Appendix F: Agency Coordination

United States Department of the Interior

**Biological Assessment
Upper Barataria Basin, Louisiana Feasibility Study with
Integrated Environmental Impact Statement**

Figure 8. Map of water control structures and other features associated with the TSP.

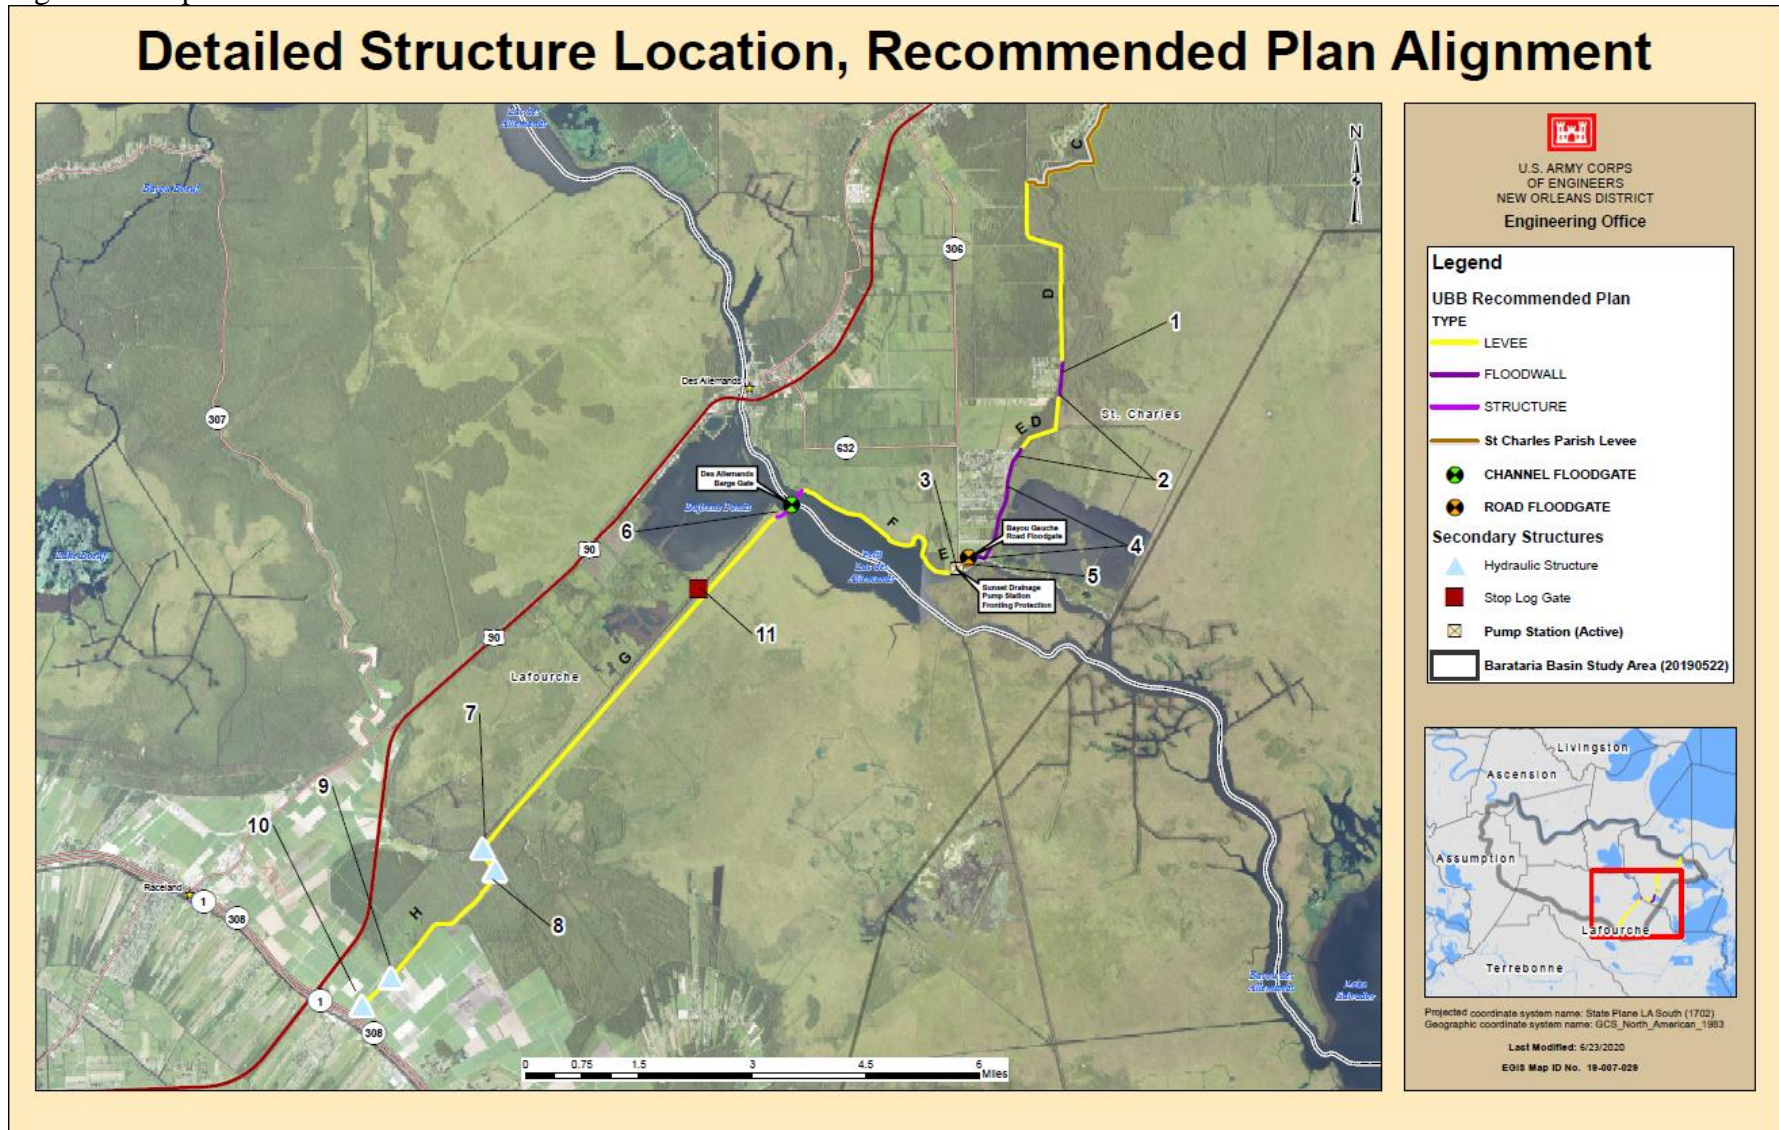
Each of these three alternatives includes a 270-foot-wide barge gate to preclude storm surge flooding within the protected area. The wing walls of that floodgate structure would include 12 auxiliary drainage gates to provide a total cross-sectional area greater than that at the existing railroad crossing located adjacent to the U.S. Highway 90 crossing. The TSP also includes two small culvert structures through the levee in Reach

G (southwest of Bayou Des Allemands) to maintain water exchange across the marsh. A 45-foot-wide water control structure would also be installed in Bayou Gauche at its junction with Bayou Des Allemands to reduce induced storm surge northward up that bayou (Figure 8).

2. The existing Bayou Des Allemands channel cross-section (in square feet) should be provided to enable assessment of potential structure related fisheries access impacts.
3. The project floodgate structures should be designed to handle the discharge associated with the two Mississippi River diversions identified in the 1993 CWPPRA Louisiana Coastal Wetlands Restoration Plan without corresponding widescale hydroperiod increases.
